AGENDA
CITY OF CREVE COEUR
PLANNING AND ZONING
300 NORTH NEW BALLAS RD
JUNE 20, 2023
6:00 PM

**APPLICATION TO PLANNING AND ZONING COMMISSION
#23-018: AN APPLICATION FOR A MINOR SITE PLAN INCLUDING
EXTERIOR MATERIAL ALTERATIONS, LIGHTING, PATIO, AND
LANDSCAPING FOR 717 OFFICE PARKWAY**

Figure 1: Existing façade of 211 N. Lindbergh Boulevard

Figure 6: Proposed raised patio with new railing and retaining wall.

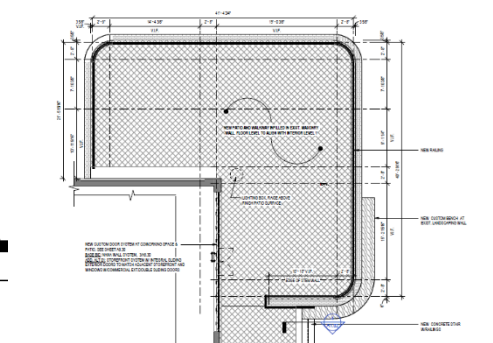
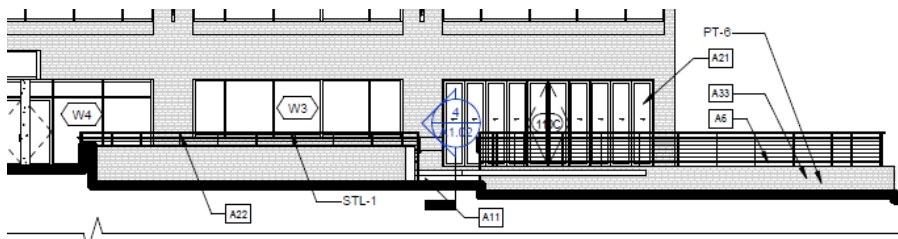
The site includes an existing at-grade patio area that will be raised to first level height in order to accommodate ADA access. The patio will include new handrails and a retaining wall around the base. Staff is asking that the material for the retaining wall be a tan color. The patio area will also include a custom bench to serve as an outdoor gathering space for the office.

Figure 7: Proposed Landscaping Plan

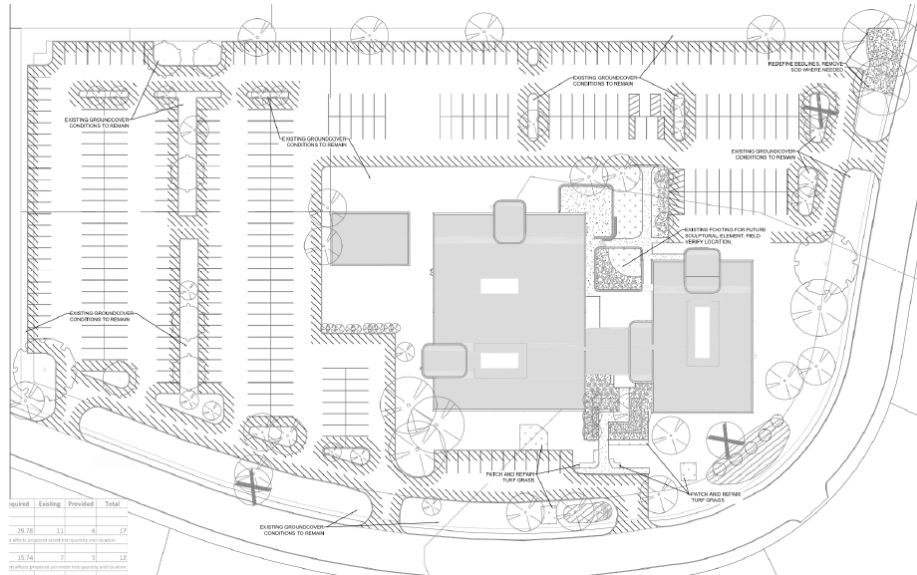
The landscaping plan provides additional landscaping around the building and throughout the site. The plan includes a mix of native trees, perennials, and evergreen shrubs. Staff noticed while reviewing the site that there are a few missing trees from the parking lot islands and the replacement of any missing parking lot island trees has been added as a condition. Due to existing site conditions including a utility easement, there is limited space for street trees but 6 additional trees are part of the proposal.

5. Any missing trees from the parking lot landscape islands shall be replaced with a tree of minimum 2.5 caliper inches at time of planting.
6. All lighting shall comply with Section 405.680 and 405.810 of the Zoning Ordinance, including the shielded and downcast angle of the new fixture heads, and with the lighting levels as shown on the photometric plans for the canopy structures, as submitted on May 19, 2023.

Figure 6: Proposed Landscaping Plan

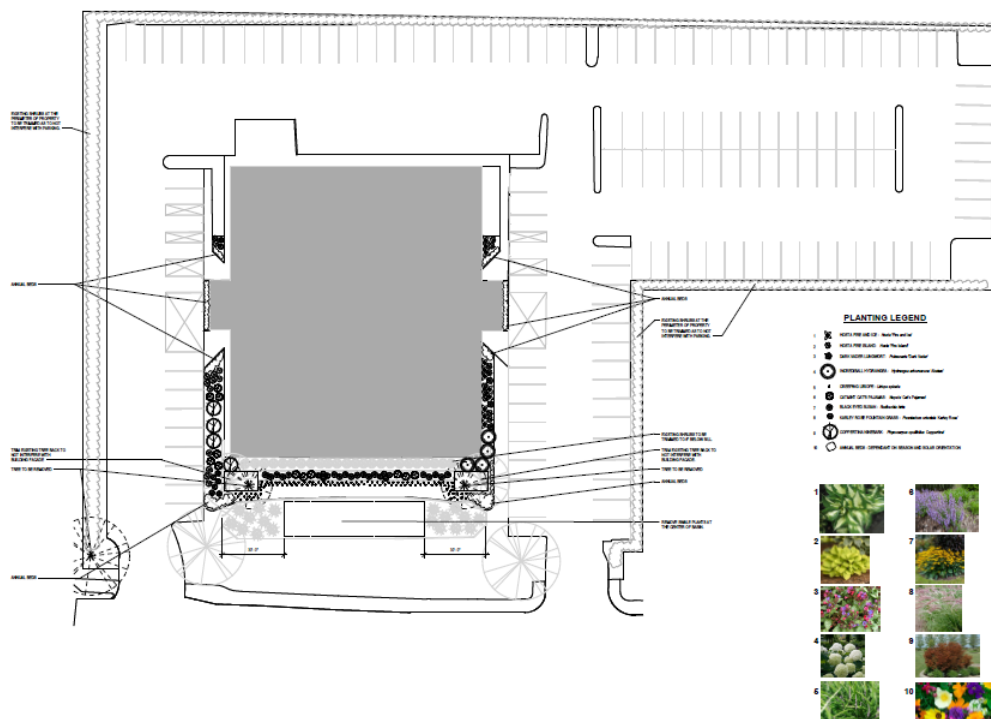
The landscaping plan provides additional landscaping around the building. The plan includes a mix of native plants and seasonal plants to fill in around the existing evergreen shrubs. Staff noted that one of the plants proposed, #5. “Creeping Liriope” is listed as an invasive species by the Missouri Botanical Gardens. Staff have added a condition of approval that this plant be removed and replaced with additional evergreen shrub varieties to provide a year-round covering. Staff also noticed while reviewing the site that there is at least one missing tree from the parking lot islands and the replacement of any missing parking lot island trees has been added as a condition.
